ADDENDUM NO. 1 TO PROJECT NO. 47010

ELECTRICAL WORK REPLACE EXISTING FIRE ALARM SYSTEM NEW YORK STATE CAPITOL STATE STREET ALBANY, NY

November 26, 2025

DRAWING NUMBER:
FAR-102

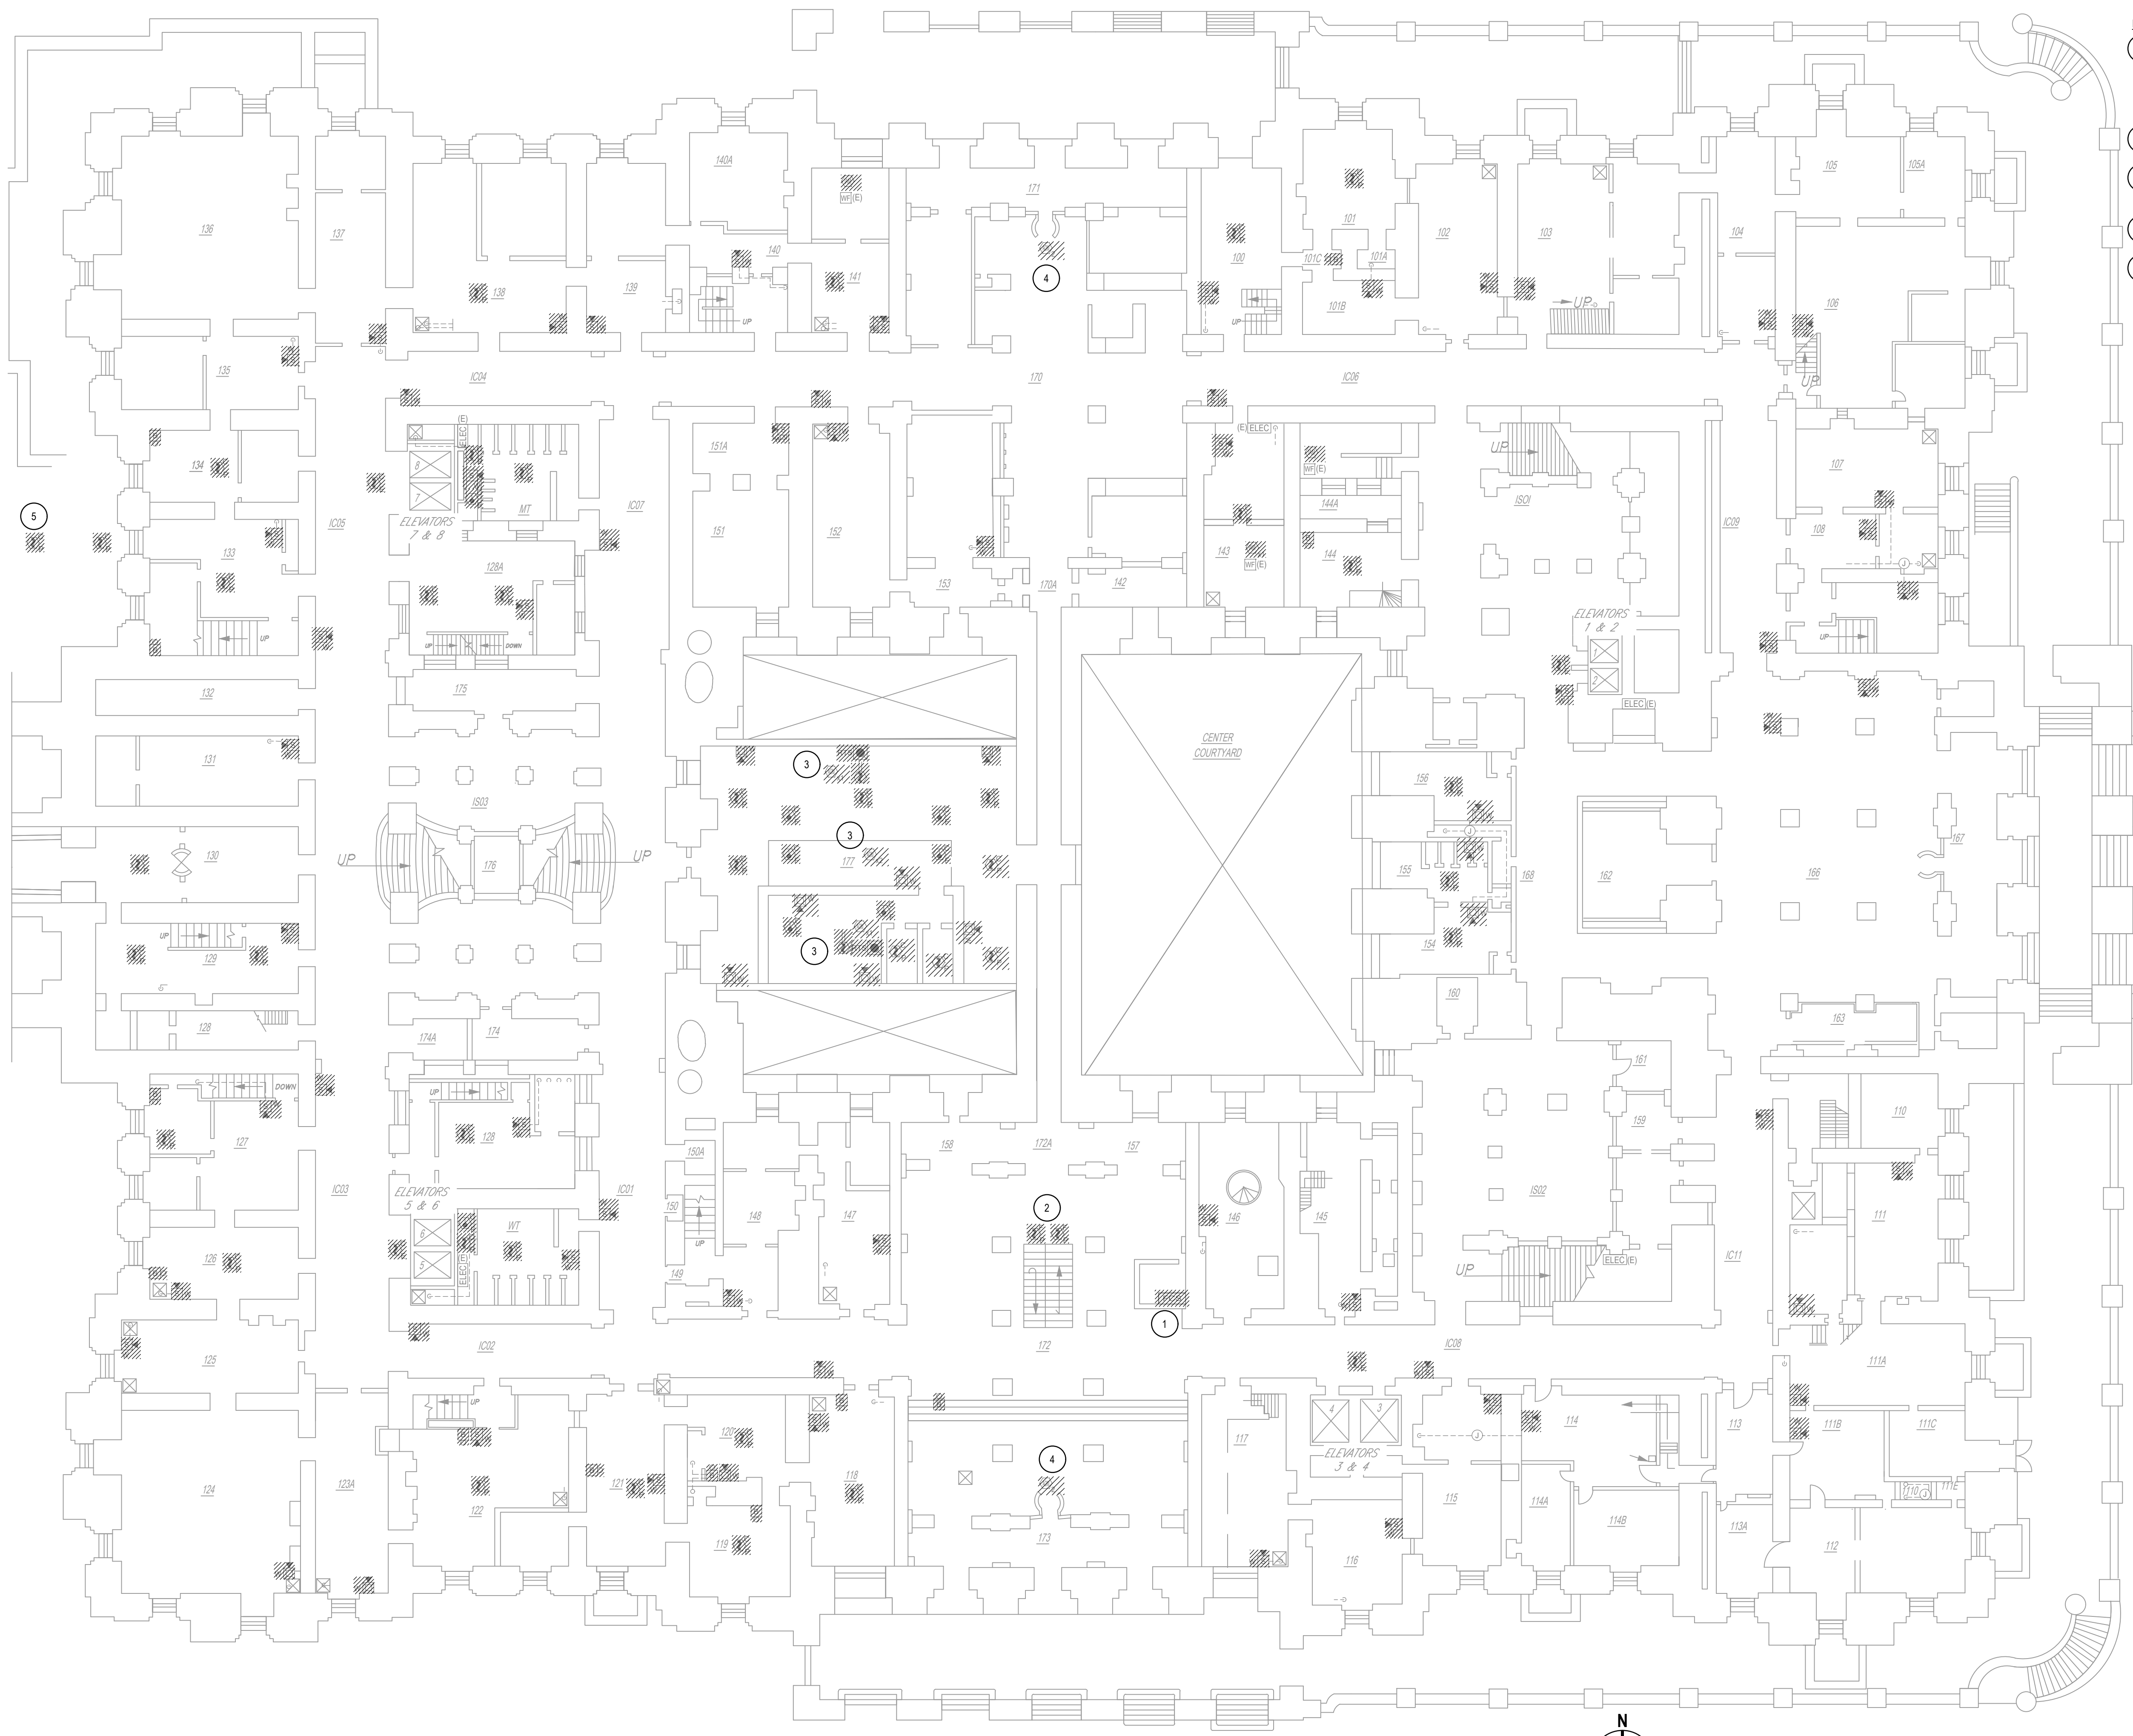
2
SCALING NOTE:
BUILDING BACKGROUND
SCALE HAS BEEN
UPDATED.

DRAWING NUMBER:
FAR-103

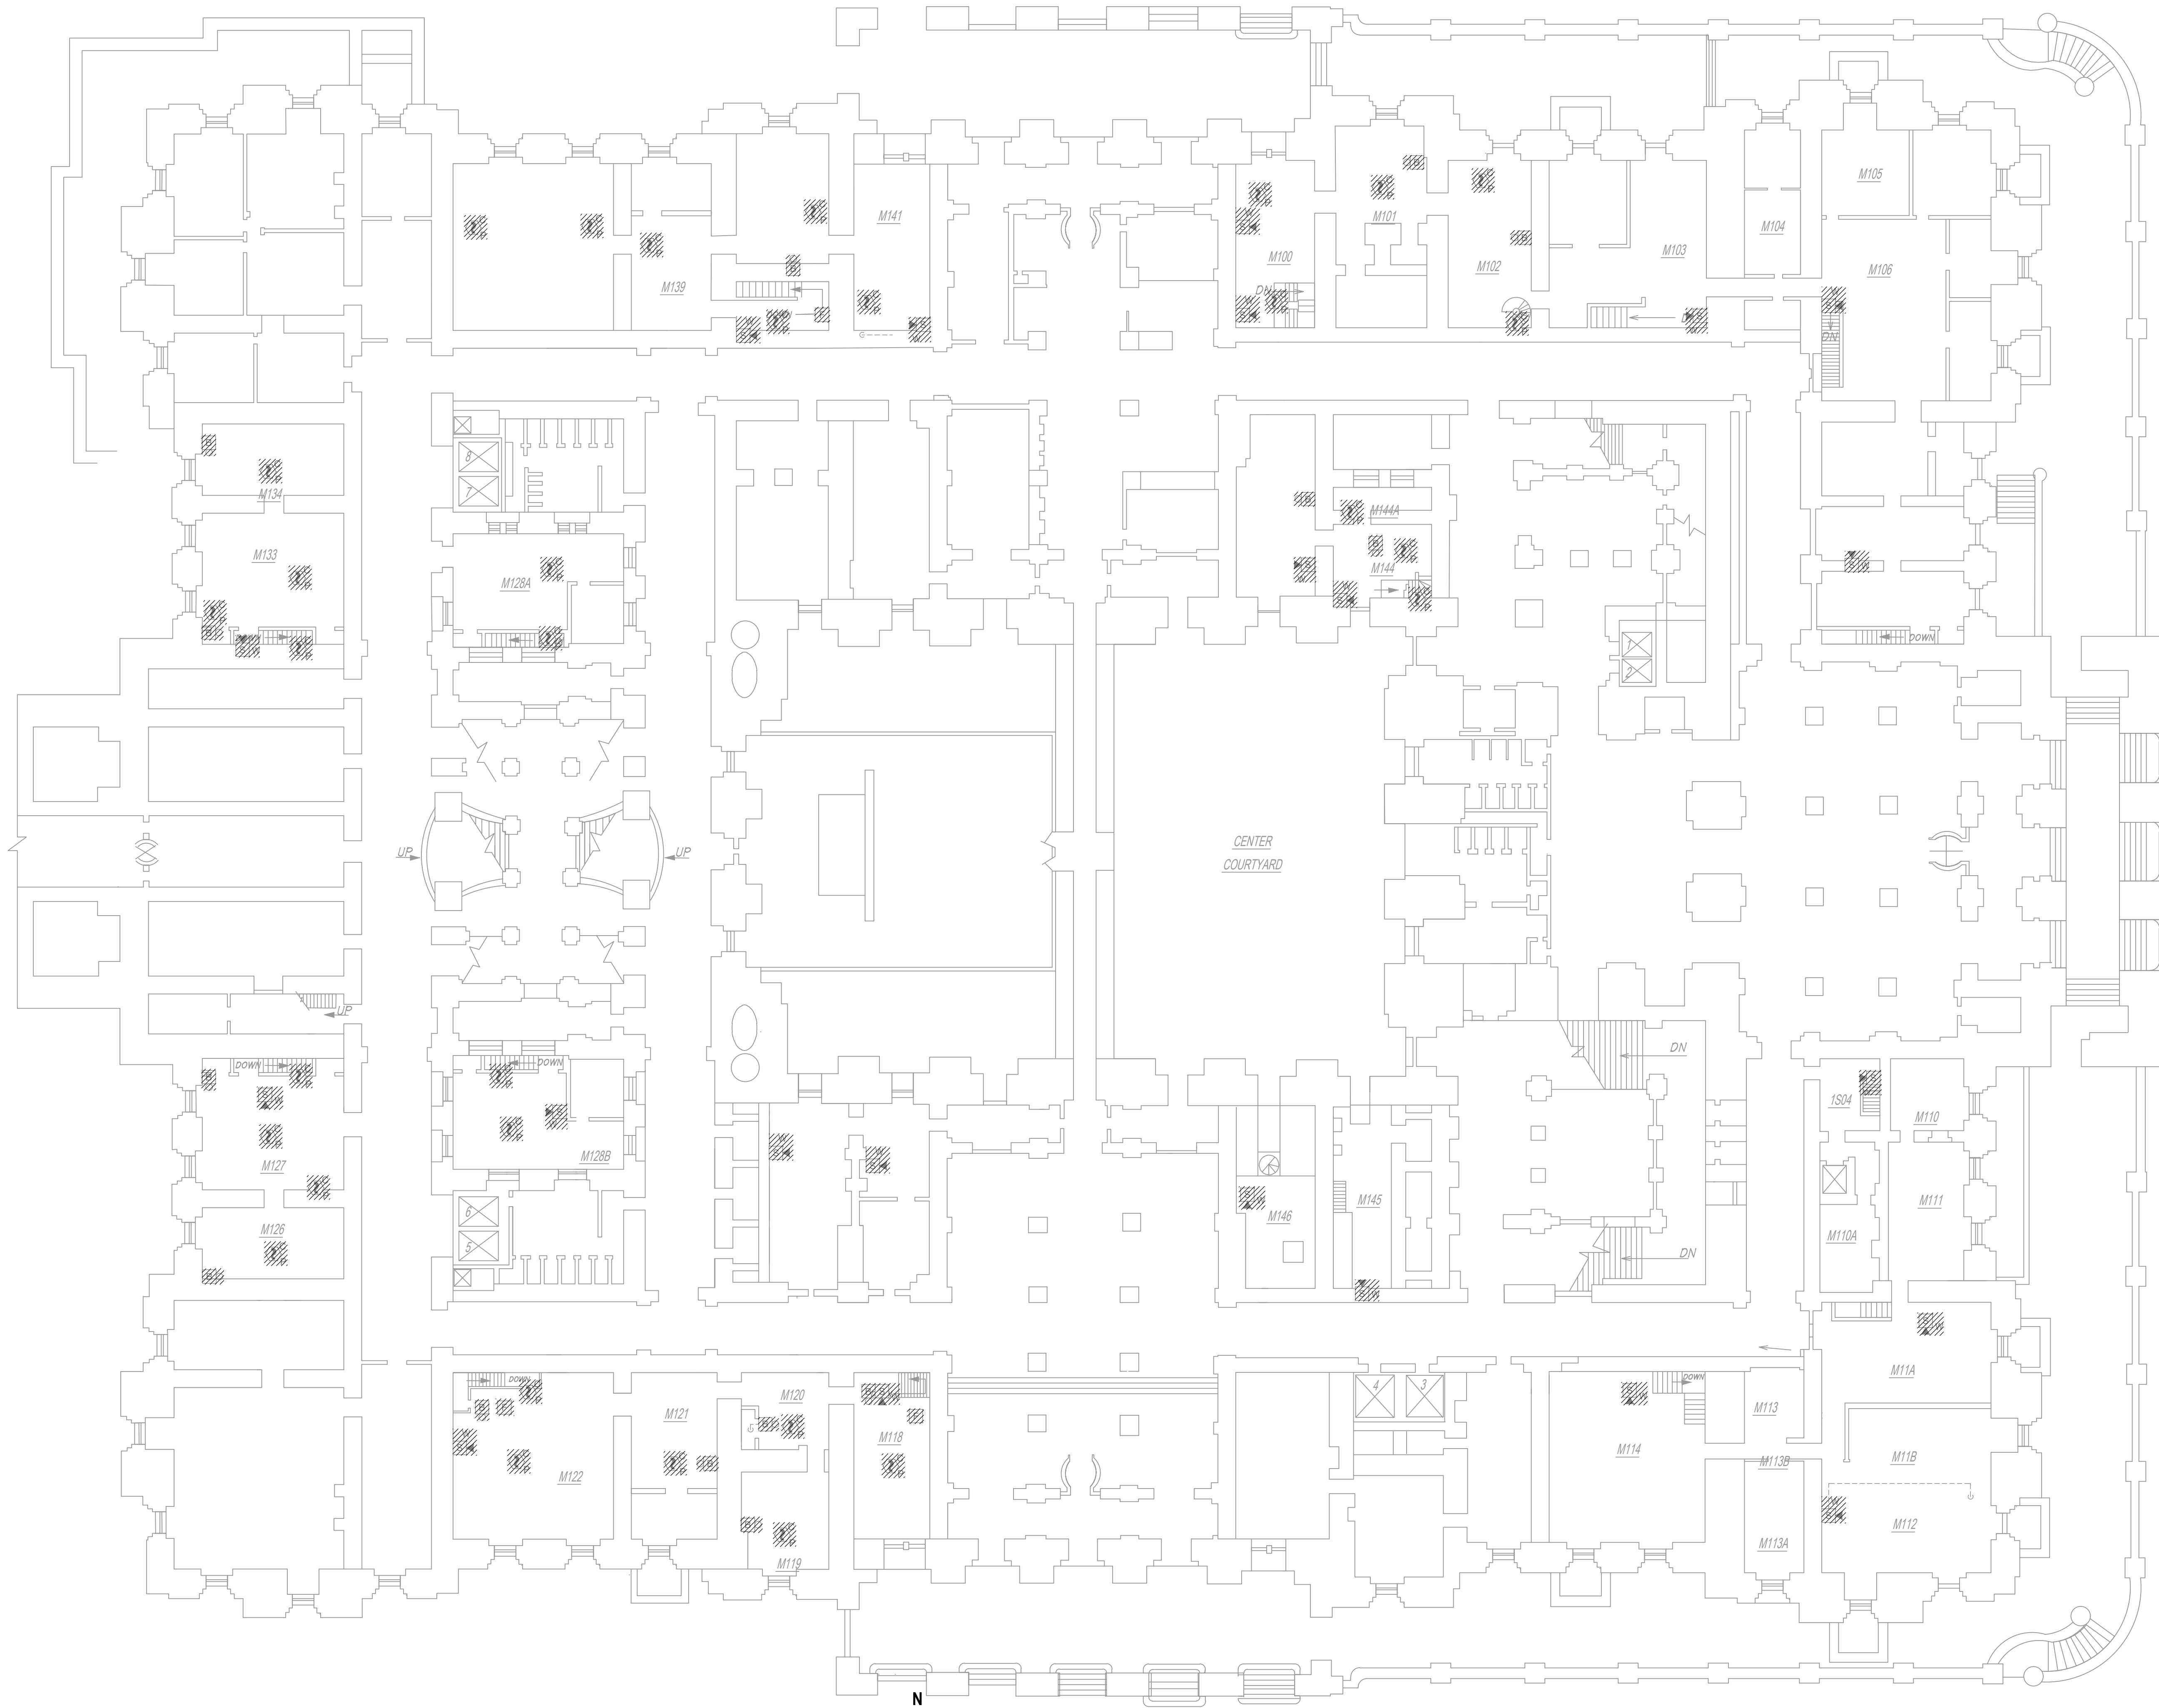
SCALING NOTE:
BUILDING BACKGROUND
SCALE HAS BEEN
UPDATED.

DRAWING NUMBER:
FAR-104

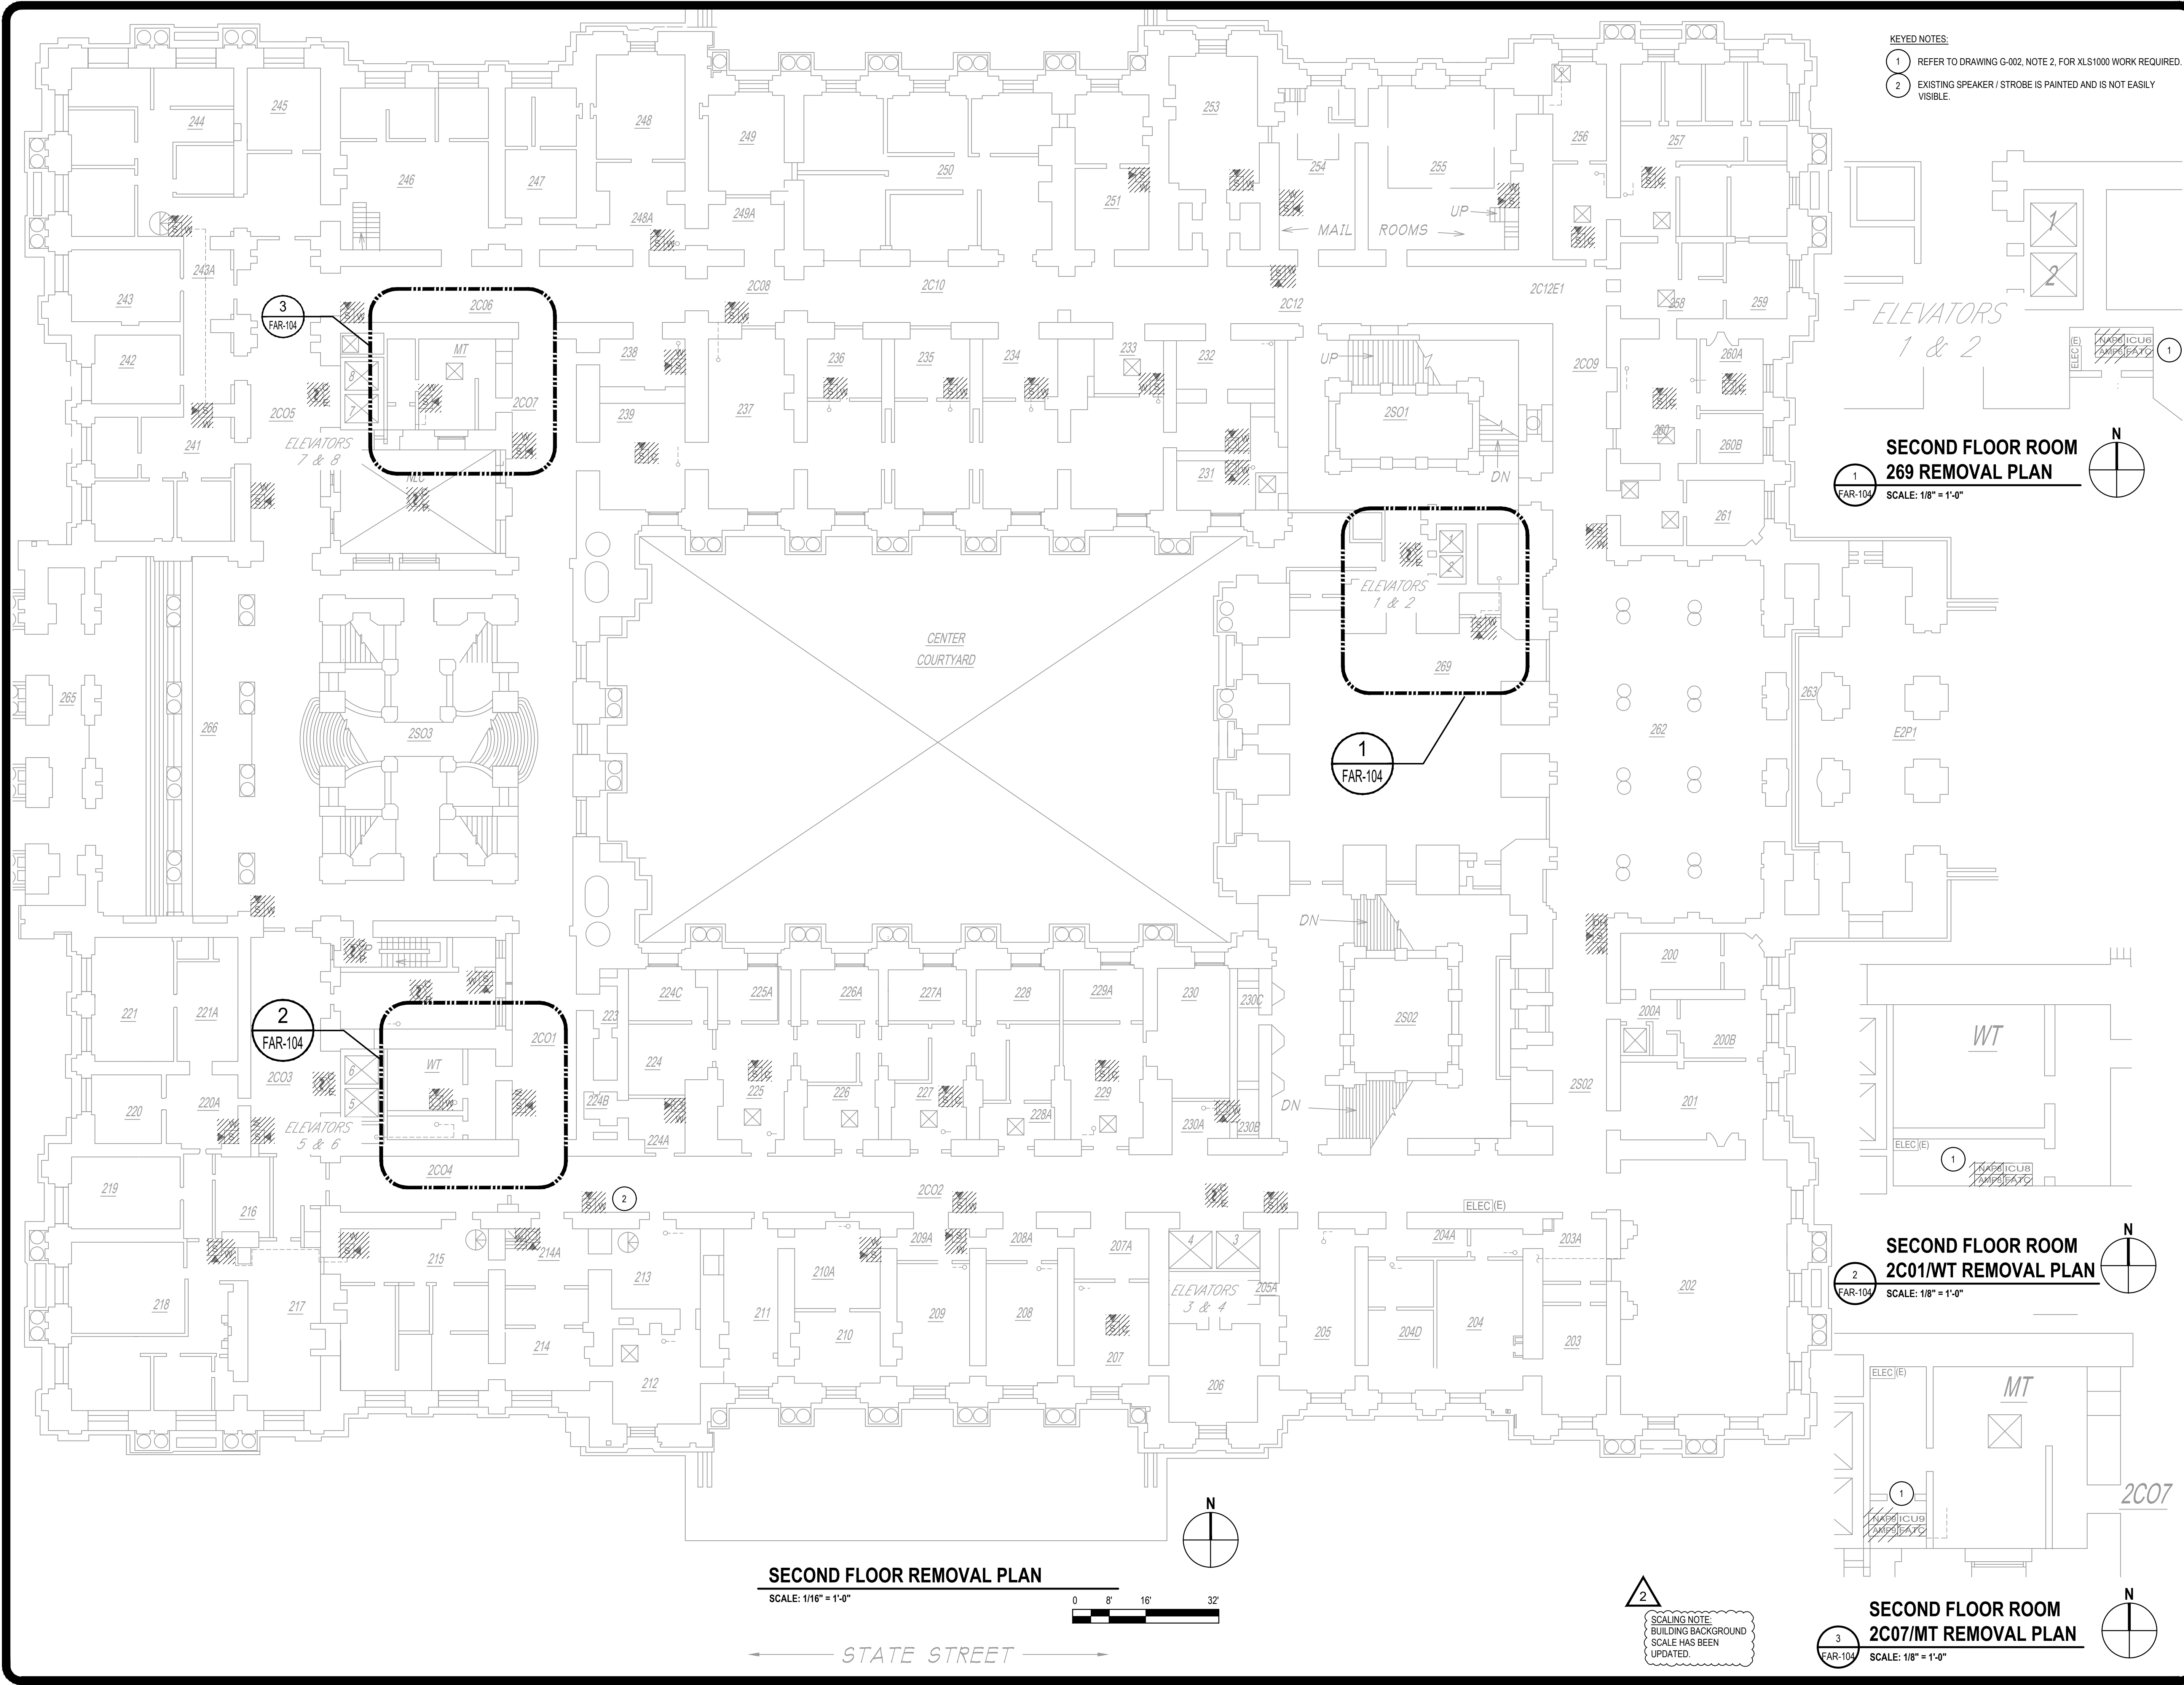
SCALING NOTE:
BUILDING BACKGROUND
SCALE HAS BEEN
UPDATED.
